UNITED STATES PATENT AND TRADEMARK OFFICE

APPLICATION NO.	FILING DATE	FIRST NAMED INVENTOR	ATTORNEY DOCKET NO.	CONFIRMATION NO.
10/612,918	07/07/2003	Kelly F. Williams	C525 0254 GNM/ld	6941
720	7590	02/08/2006	EXAMINER	
OYEN, WIGGS, GREEN & MUTALA LLP 480 - THE STATION 601 WEST CORDOVA STREET VANCOUVER, BC V6B 1G1 CANADA			NGUYEN, JIMMY T	
			ART UNIT	PAPER NUMBER
			3725	
DATE MAILED: 02/08/2006

Office Action Summary

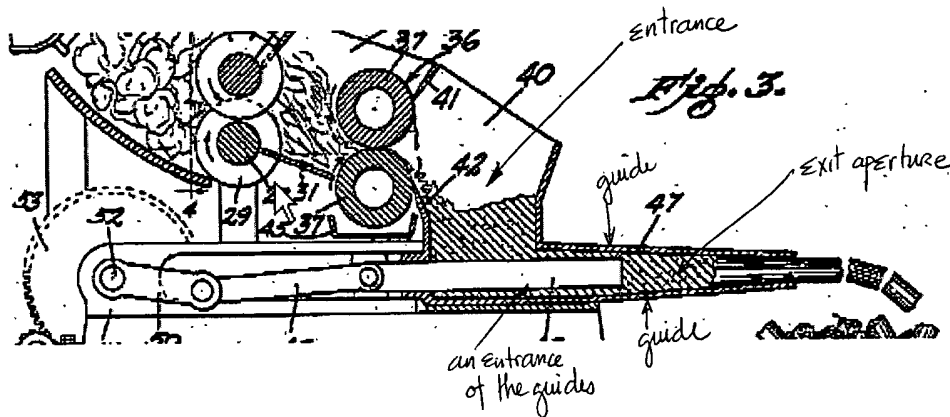
Regarding claim 1, Paxton discloses a compactor comprising: an elongate compression chamber having an entrance and an exit aperture (see the illustration below); a pair of opposing input rollers (37) located at the entrance to the pre-compression chamber, at least one of the rollers provided with rotational drive (page 2, lines 12-14); a moveable plunger (48) operable to sweep a volume of the pre-compression chamber between the entrance and the exit. Note that the limitation “slipsheet” is not positively claimed and it is being claimed as an intended use in the preamble. Paxton discloses the compactor as claimed as set forth above; therefore, the compactor is capable of compacting slipsheet.

Regarding claim 2, the pre-compression chamber has a transverse cross section that is inwardly tapered towards the exit aperture (see the illustration above).

Regarding claim 3, the pre-compression chamber comprises a pair of spaced apart guides defining a passageway having an entrance at one end thereof and defining the exit aperture at the other end thereof, the passageway inwardly tapered at least in a portion in proximity to the exit aperture (see illustration above).
